ILLINOIS COMMERCE COMMISSION**DOCKET NO. 02-0480****RESPONSE OF CONSUMERS ILLINOIS WATER COMPANY
TO ICC DATA REQUEST NO. WD 1.01**

WD 1.04 Please provide a detailed distribution map(s) showing CIWC's existing water distribution mains and the route of the proposed main extension(s) to provide water service to the residents in the Village of Grant Park and to the Growth/Housekeeping Area.

**RESPONSE OF CONSUMERS ILLINOIS WATER COMPANY
TO ICC DATA REQUEST NO. WD 1.08**

WD 1.09 Please provide all workpapers, notes, memorandums and/or reports supporting the construction of the six-inch main instead of having an eight-inch main serving Grant Park or Growth/Housekeeping Area.

EXHIBIT J

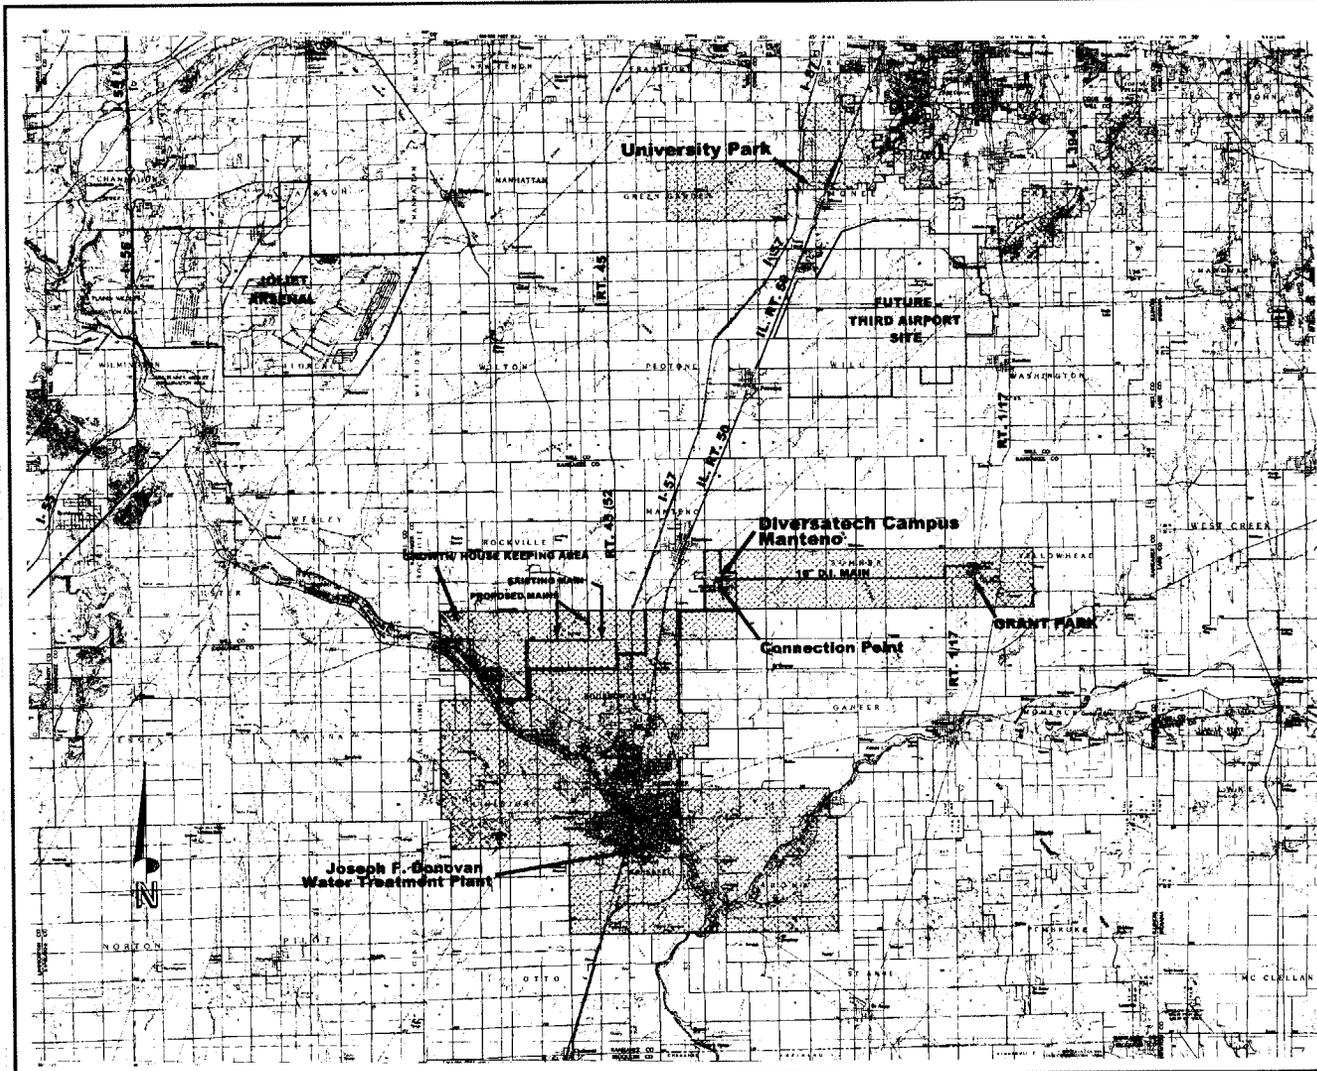
WD 1.08 Provide the additional number of residents and/or commercial businesses that may receive water service within five years from the proposed main extension(s) to Grant Park or Growth/Housekeeping Area.

RESPONSE: Sixteen residences are located adjacent to the proposed main extension to Grant Park and which could be served immediately if service were requested. Also, the construction growth areas of Kankakee and Will County. Also, the Main if extended, a further extension to such areas in Will County may be feasible to connect CIWC's water systems in Dixie Dells, Calumet Gardens, Village Woods and University Park, which presently experience hard water and iron conditions. If an extension to University Park is completed, CIWC will be able to provide the high-quality, softened water others enjoy to CIWC's Customers in Will County, and also the possibility of serving an additional 17,700 residents not currently served by CIWC. These include the Villages of Beecher, Momence, Crete, and Monee. In addition, 2,300 residents in CIWC's Willowbrook Estates water system could be potentially served from the extension. CIWC is in preliminary discussions with the Village of Beecher, City of Momence, the Village of Crete and the Village of Monee regarding the potential of extending the water main further. Please refer to Table 1, Exhibit J and Exhibit M.
